Report
of
Preliminary Investigation

FAILURE OF HANGER BOLTS ON
SUPPRESSION CHAMBER SUCTION HEADER
at
Quad Cities Nuclear Station, Unit -2
Commonwealth Edison Company
Iowa-Illinois Gas and Electric Company
Rock Island, Illinois

Report No. DC-98

ANALYSIS OF SUPPORT BARS AND BOLTS
OF 24" SUCTION HEADER
FOR SUPPRESSION CHAMBER

SHEAR STRESS OF ORIGINAL BOLT

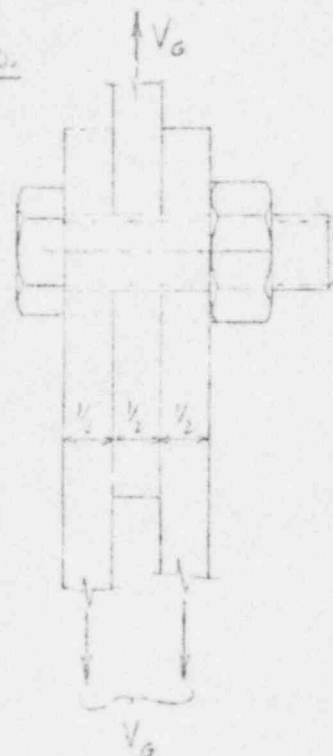
IN $\frac{3}{4}$ -10 BOLT, FULL LENGTH THREAD.
FOR GRAVITY LOADING

$$\text{SHANK AREA} = 0.442 \text{ IN.}^2$$

$$A_v = 2(0.442) = 0.884 \text{ IN.}^2 \text{ (DOUBLE SHEAR)}$$

$$\tau_g = \frac{V_g}{A_v} = \frac{8015}{0.884} \text{ ← AVERAGE, PAGE 9}$$

$$= \underline{9067 \text{ PSI}} < F_v = 10,000 \text{ PSI}$$

NOTE THAT ALLOWABLE STRESS
 OF 10,000 PSI IS BASED ON
 UNTHREADED BODY AREA,
 PER § 1.5.21, PAGE 5-20 [4].

SHEAR STRESS IN SHANK (FULL 2A)
OF REVISED BOLT FOR GRAVITY LOAD

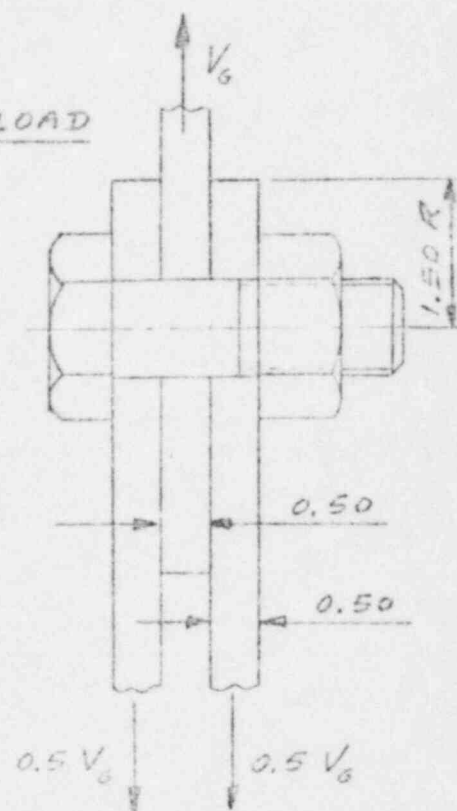
1"-8 BOLT OF A-325 STEEL
 IN REAMED HOLE

THREADS ARE EXCLUDED
 FROM SHEAR PLANES.

REVISED BARS ARE $3" \times \frac{1}{2}"$

SHANK AREA = 0.7854 IN.²

$$\tau_g = \frac{V_g}{A_v} = \frac{8015}{2 \times 0.7854}$$

$$= 5102 \text{ PSI}$$

$\angle F_v = 22000 \text{ PSI}$ WHEN THREADING IS
EXCLUDED FROM SHEAR PLANES

EVALUATION OF UNEVEN SPACING OF SUPPORTS

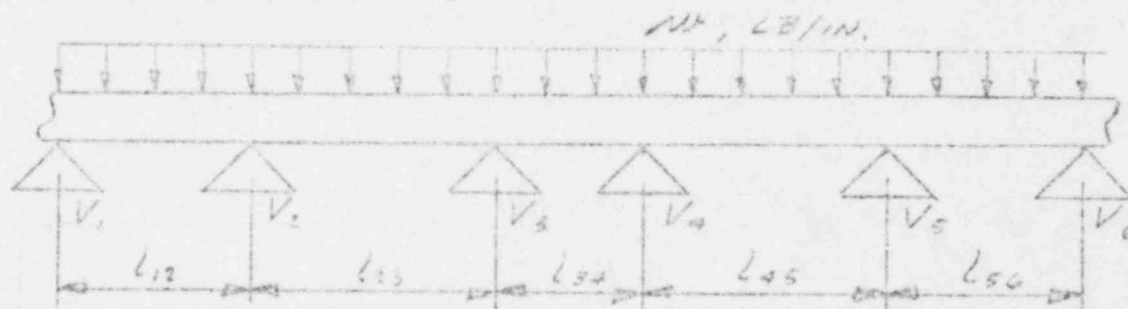
ANGULAR SPACING OF HANGER AND NOZZLE SUPPORTS IS SHOWN BY THE SKETCH OF SUPPORT SPACING ON PAGE 14.

LET US MAKE AN APPROXIMATE CALCULATION OF THE EFFECT OF UNEVEN SPACING ON SUPPORT LOADS, MODELING THE HEADER AS SIXTEEN (16) UNIFORMLY LOADED SIMPLE BEAMS WITH STRAIGHT SPANS EQUAL TO THE NOMINAL ARCS.

$$V_{i,i+1} = 0.5 W (l_{i-1,i} + l_{i,i+1})$$

CASE	ANGULAR SPACING DEG		ARC SPACING IN.		REACTION %
	$\alpha_{i-1,i}$	$\alpha_{i,i+1}$	$l_{i-1,i}$	$l_{i,i+1}$	
1					V_i
2	31.64	22.50	95.97	99.78	98.1
3	22.07	22.50	97.87	99.78	99.0
4	22.50	22.50	99.78	99.78	100.0
5	22.93	22.93	101.69	101.69	101.9
6	45.86	22.50	203.38	99.78	151.9

NOTE: 1) CASE 4 IS RATED "PAR" OF 100% BECAUSE IT REPRESENTS "IDEAL" UNIFORM SPACING.

2) FOR CASE 6, NOZZLES ARE UNLOADED.
